DCUSA Consultation		At what stage is this document in the process?
<h2>DCP 284</h2> <h3>The application of scaling to generation credits in the CDCM</h3> <p>12 October 2016</p> <p>Standard Change</p>		01 – Change Proposal
		02 – Consultation
		03 – Change Report
		04 – Change Declaration
<p>Purpose of Change Proposal:</p> <p>DCP 284 seeks to amend the calculation of credits for embedded generation to more closely reflect the benefits they bring to Distribution Network Operators by including an element of scaling.</p> <p>This document is a Consultation issued to DCUSA Parties and any other interested Parties in accordance with Clause 11.14 of the DCUSA seeking industry views on DCP 284.</p>		
	<p>The Workgroup recommends that this Change Proposal should proceed to Consultation.</p> <p>Parties are invited to consider the questions set in section 10 and submit comments using the form attached as Attachment 2 to dcusa@electralink.co.uk by 27 February 2017</p> <p>The Working Group will consider the consultation responses and determine the appropriate next steps for the progression of the Change Proposal (CP).</p>

<p>Impacted Parties: Distribution Network Operators (DNOs), Distributed G

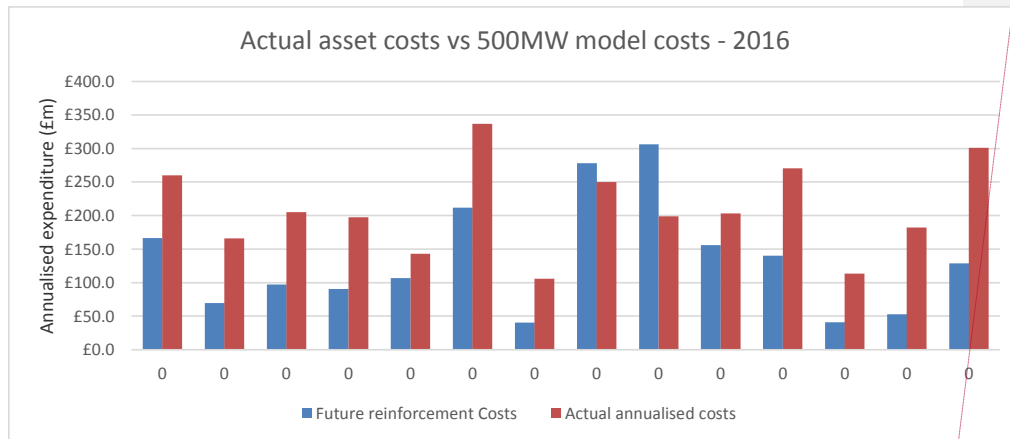
Commented [DT10]: Andy Pace to provide new graph updating DNO label from SSEPD to SSEN name. The graph heading will also need to be updated.
